DOCUMENT 00 90 10

ADDENDUM No. 3

- A. The Construction Contract is known as: *Mountain Green BNR Wastewater Treatment Plant*
- B. Date of this Addendum: 2/3/2023.
- C. All other provisions in the contract to remain in full force and effect.

BNR WWTP 2022
CIVIL SITE
DEMOLITION PLAN – ZONE 3

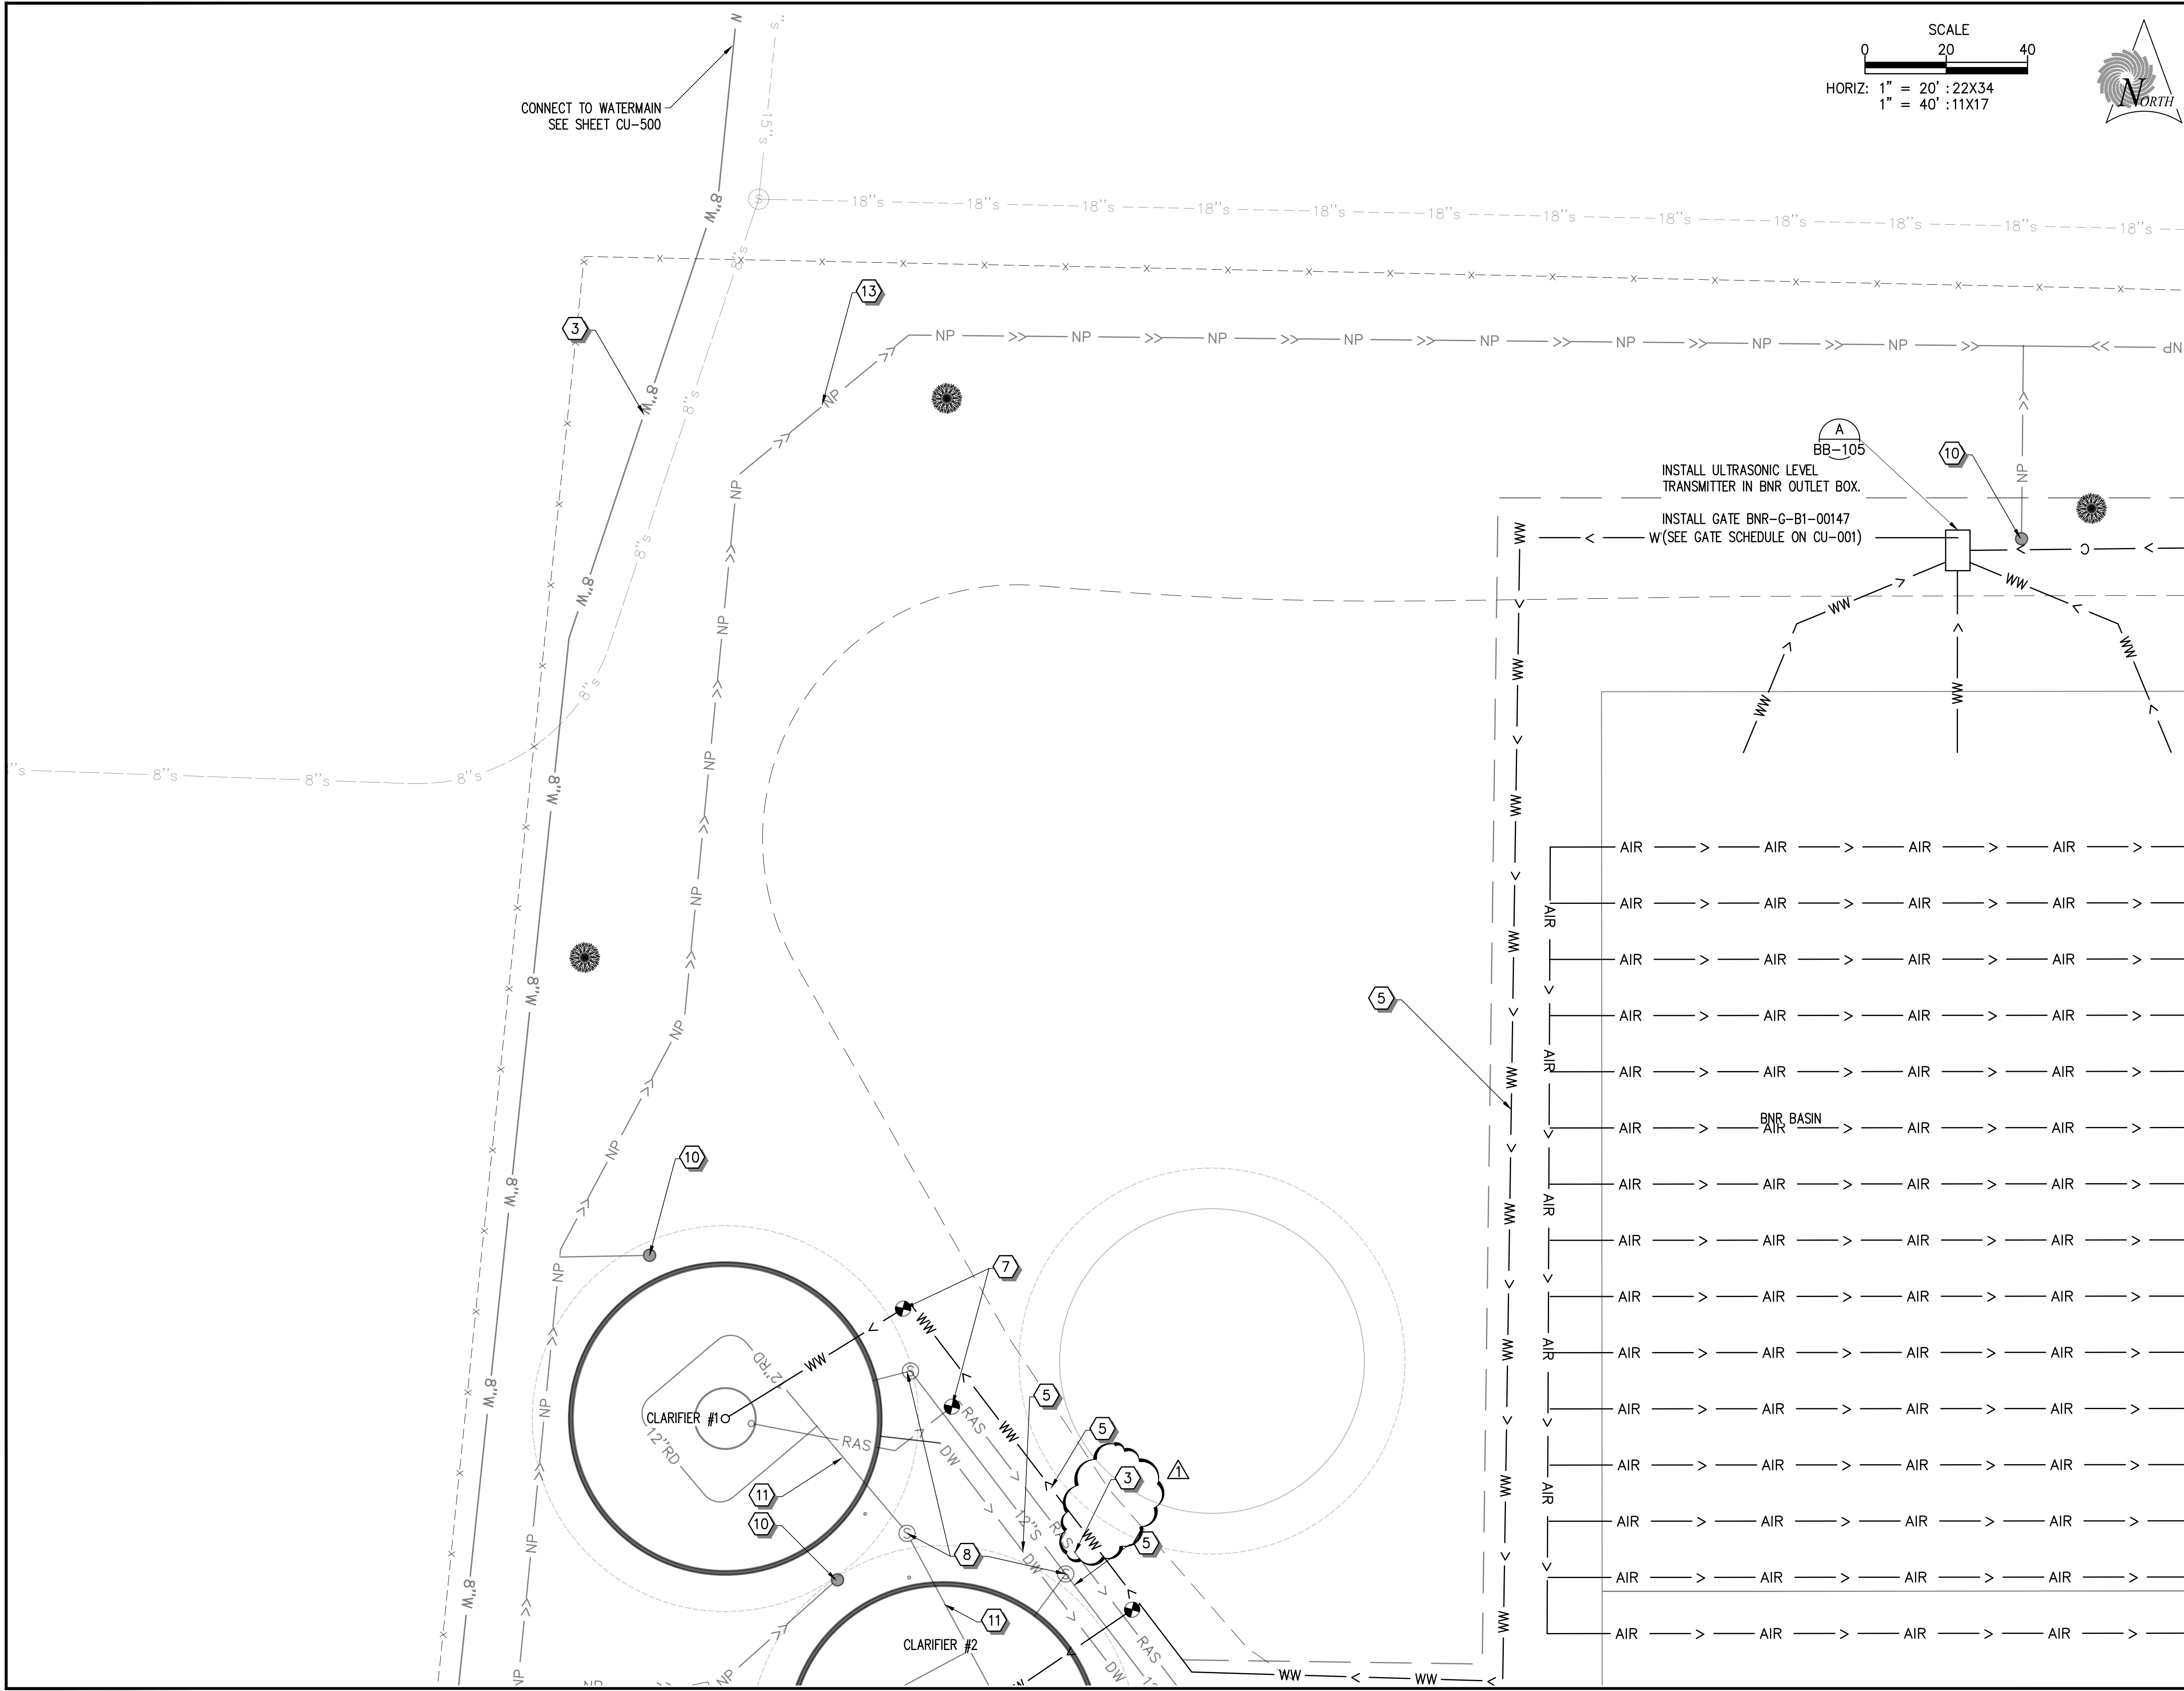
- 1) CS-103
 - i. Removed note #2 to calling out power pole removal. Power pole should remain.
- 2) CU-101, CU-102, CU-103
 - i. Changed RAS line note to callout as C-900, note #3.

BNR WWTP 2022
CIVIL UTILITIES
SITE PIPING - ZONE 1

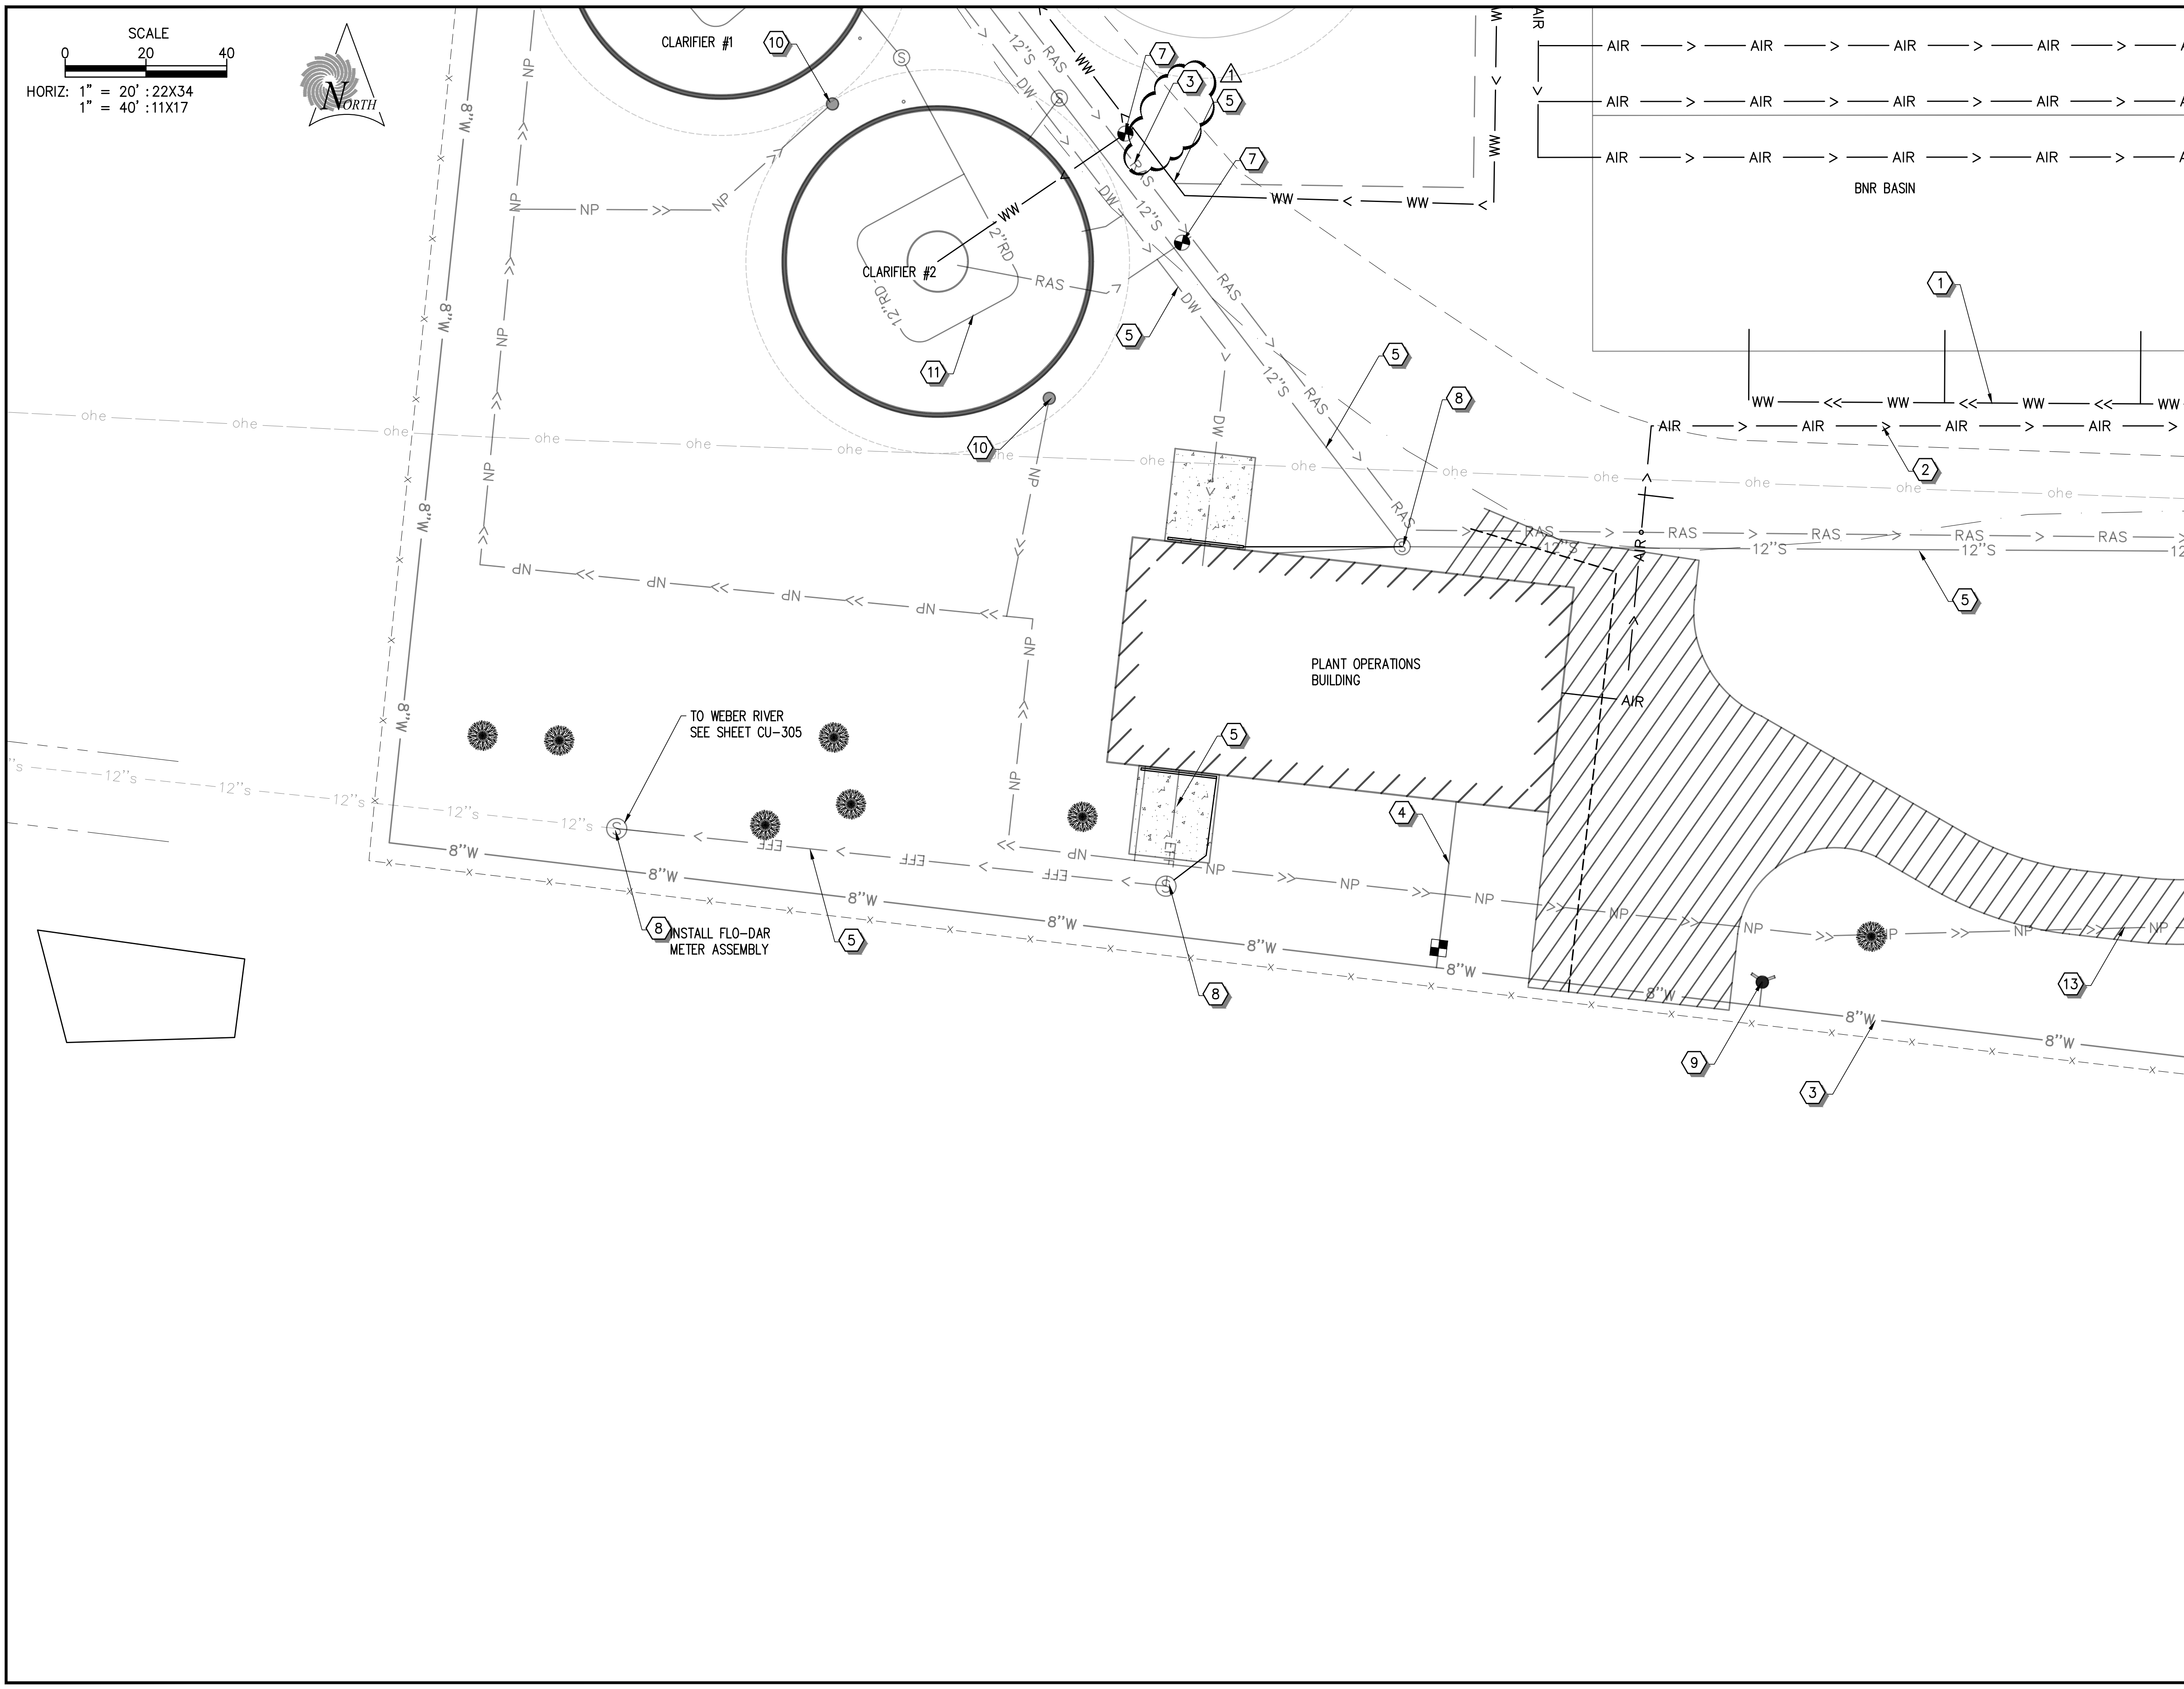
- 1) Question: The plans don't show gutter but it is mentioned in the spec. Is it intended ?
Response: No gutter intended.
- 2) Question: The RAS line from the clarifier to the headworks building is shown as SDR35 and labeled a gravity line. This is a pumped line should the pipe type be changed to a pressure pipe?

Response: This line should be C900, see revised Civil Sheets attached.
- 3) Question: Can you provide the Geotech for the project?
Response: Yes, see Geotech report attached.
